RE: FLOODPLAIN MANAGEMENT ISSUES,

PROPOSED HOXTON PARK AIRPORT REDEVELOPMENT

COWPASTURE ROAD, HOXTON PARK.

PROPERTY DESCRIPTION	HOXTON PARK AIRFIELD
LOT 400 D.P. 1141900 COW PASTURE ROAD HOXTON PARK	PROPOSED STORMWATER TREATMENT
SURVEYED DATUM	PROJECT No. DISCIPLINE NUMBER REV.
DJ/BJ A.H.D.	150126 - SK - 069   A

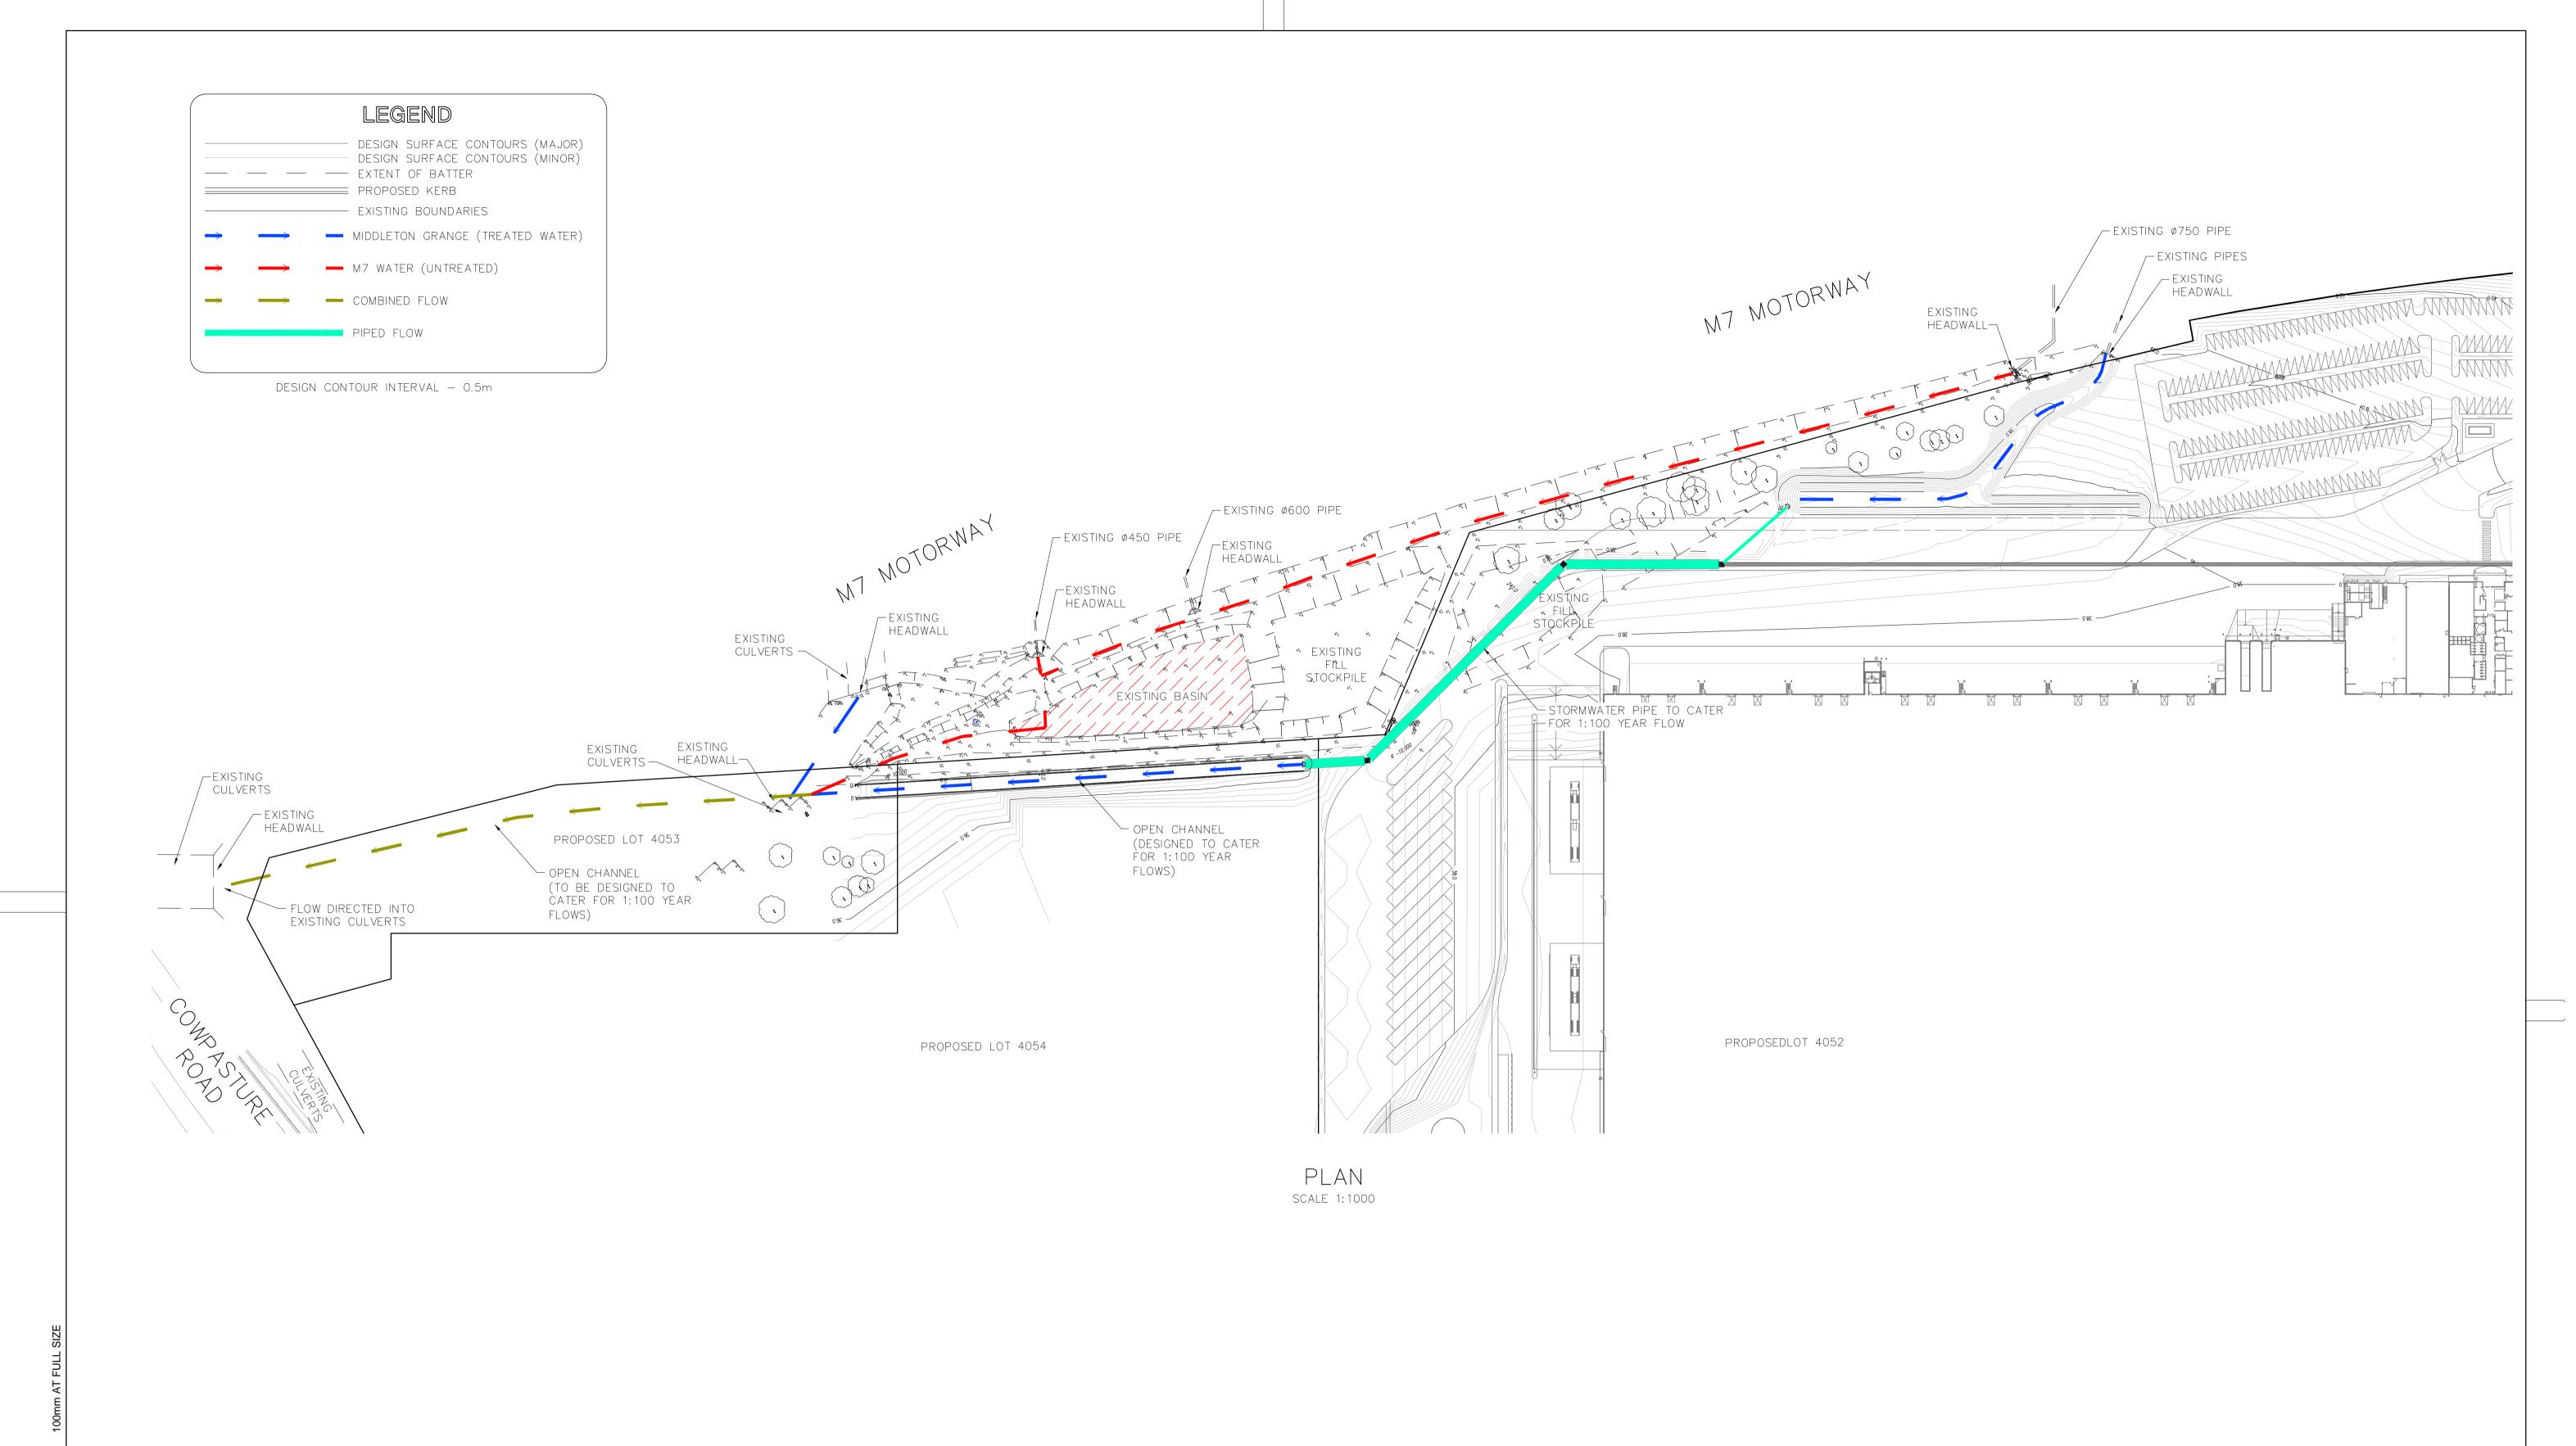
We note Councils concerns in relation to the conflict with the existing channel conveying stormwater from both the existing M7 culvert crossings and the M7 surface water drainage. As part of the overall internal stormwater design for the site, these culverts and surface water drainage infrastructure are proposed to be conveyed to a relocated channel sized to cater for the critical 1:100 ARI design storm and conveyed toward Cowpasture Road. At Cowpasture Road this channel will be directed toward the inlet of the existing culvert structure crossing Cowpasture Road. It is understood that this structure has been sized to cater for the critical 1:100 design storm for the catchment. An indicative arrangement of these facilities is shown on Drawing 150126-SK-069-A attached.
